In the Drawing

In a separate Letter to the Official Draftsperson (copy attached), certain changes to the drawing have been proposed. Applicants submit herewith amended FIGURES 5 and 7 for the Examiner's approval. FIGURES 5 and 7 have been amended to correct certain textual errors. No new matter has been added.

Voluntary amendment to the Drawing

FIG. 5

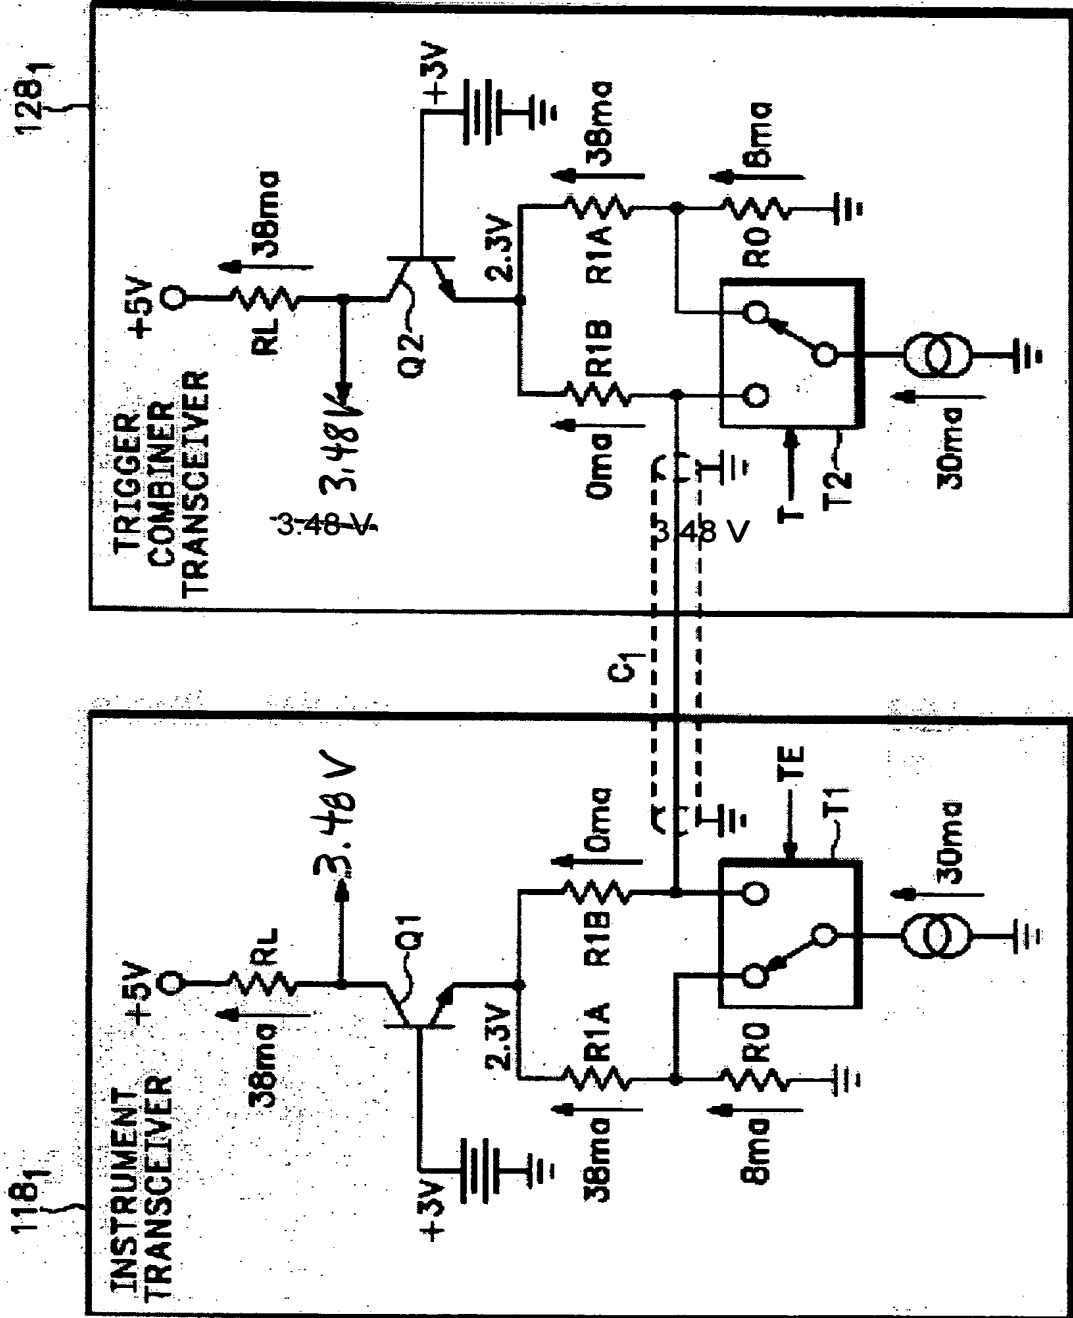
With respect to FIGURE 5, it can be seen from the corresponding calculations on page 15, lines 26-28, that the voltage at the collector of Q1 should be labeled "3.48 V". Also, the upper occurrence of the "3.48 V" text in the right-hand side of the FIGURE 5, has been rotated 90 degrees for easier reading. The lower occurrence of the "3.48 V" text in the right-hand side of the FIGURE 5, has been deleted.

FIG. 7

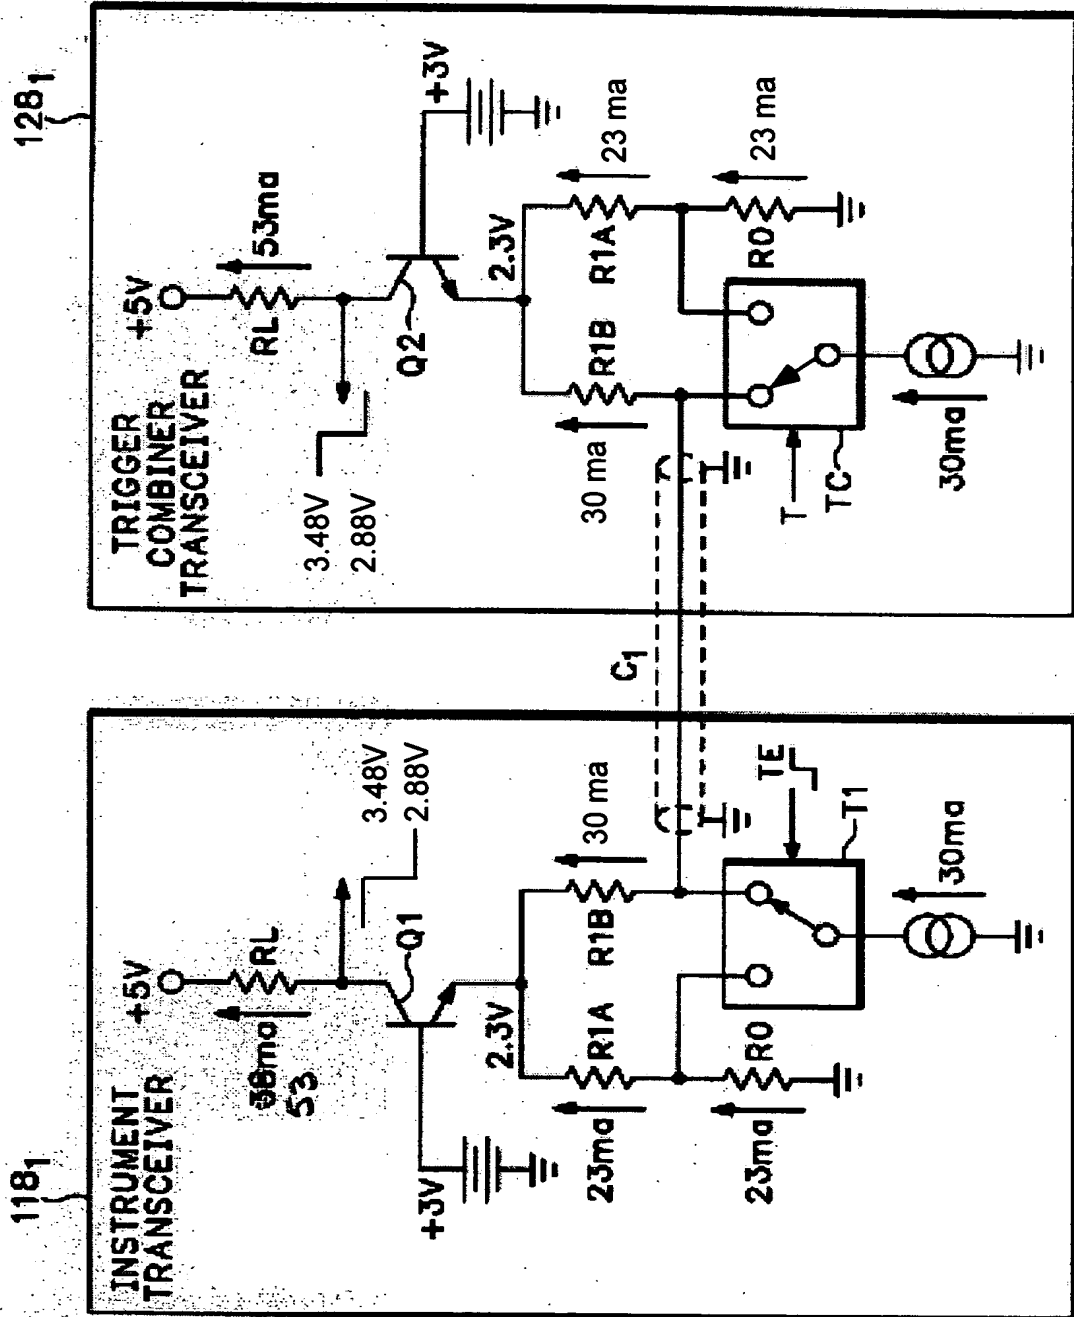
With respect to FIGURE 7, it can be seen from the corresponding text on page 16, lines 17-19, that the current through RL should be labeled "53 ma".
